Access Compliance Report

Public Rights-of-Way

Intersection ID: 12711	Main Street: E_STONEWALL_ST	Cross Street: S_TRYON_ST	Location: E
ADA ID: 82B66E9D3F97	Ramp Type: Perp	Initial Pass/Fail: Fail	Overall Compliance: No
		Severity Score: 12.5

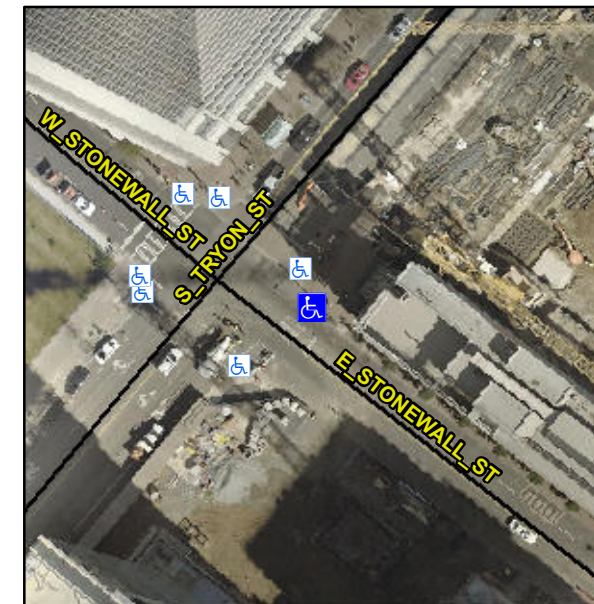
R304.2.2

Compliance	Description	Data	Compliance	Description	Data
N/A	Ramp Length (in)	77.0	No	Ramp Slope (%)	8.9
Yes	Ramp Width (in)	60.0	Yes	Ramp XSlope (%)	0.7
N/A	Flare Type LT	N/A	N/A	Flare Type RT	N/A
N/A	Flare Slope LT (%)	N/A	N/A	Flare Slope RT (%)	N/A
N/A	Flare Traversable LT?	N/A	N/A	Flare Traversable RT?	N/A
N/A	Landing Length (in)	N/A	N/A	DWS Provided?	N/A
N/A	Landing Width (in)	N/A	N/A	DWS Contrast?	N/A
N/A	Landing Slope (%)	N/A	N/A	DWS Length (in)	N/A
N/A	Landing X Slope (%)	N/A	N/A	DWS Full Width?	N/A
N/A	Landing Curb? (Y/N)	N/A	N/A	DWS Offset (in)	N/A
N/A	Shared Landing?	N/A			
N/A	Gutter Ponding?	N/A	N/A	Gutter Slope (%)	N/A
N/A	Gutter Lip Ht (in)	N/A	N/A	Gutter X Slope (%)	N/A
N/A	Painted X Walk1?	Yes	N/A	Painted X Walk2?	N/A
	X Walk 1 Direction	To SW		X Walk 2 Direction	N/A
N/A	X Walk 1 Width (in)	110.0	N/A	X Walk 2 Width (in)	N/A
	X Walk 1 Slope (%)	3.3		X Walk 2 Slope (%)	N/A
	X Walk 1 X Slope (%)	4.0		X Walk 2 X Slope (%)	N/A

Remove & Replace Entire Ramp.
